World Forum for Harmonization of Vehicle Regulations

Proposal for Amendment 3 to UN Global Technical Regulation No. 9 (Pedestrian Protection)

Submitted by the Working Party on Passive Safety*, **

"Figure 6A

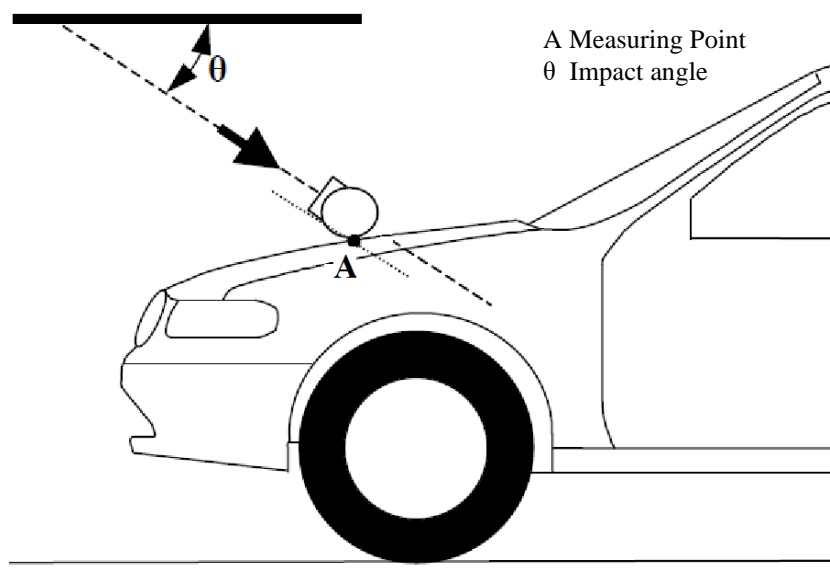
Figure 6, shall be deleted

Insert new Figures 6A and 6B, to read:

Measuring point in the vertical longitudinal plane through the centre of the headform impactor (see paragraph 3.21.1) ¹

- 3.21.1. "Measuring point" for the headform test means a point on the vehicle's outer surface selected for assessment. The measuring point is where the headform's profile contacts the vehicle's outer surface cross section in a vertical longitudinal plane through the center of gravity of the headform (see Figure 6A).
- 3.21.2. "Measuring point" for the lower legform to bumper test and the upper legform to bumper test is located in the vertical longitudinal plane through the central axis of the impactor (see Figure 6B)."

"Figure 11

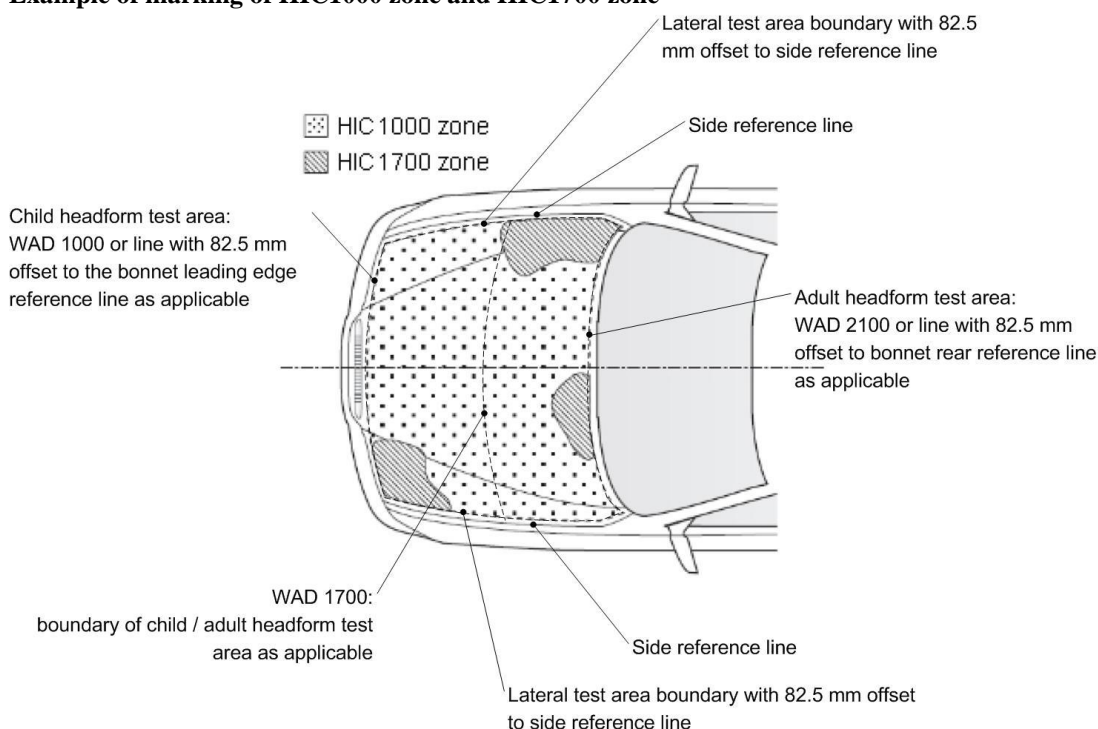
Figure 11(former), shall be deleted

Insert new Figure 11, to read:

Example of marking of HIC1000 zone and HIC1700 zone

"5.2.4.1. The manufacturer shall identify the zones of the bonnet top test area where the HIC must not exceed 1,000 (HIC1000 Zone) or 1,700 (HIC1700 Zone) (see Figure 11)."
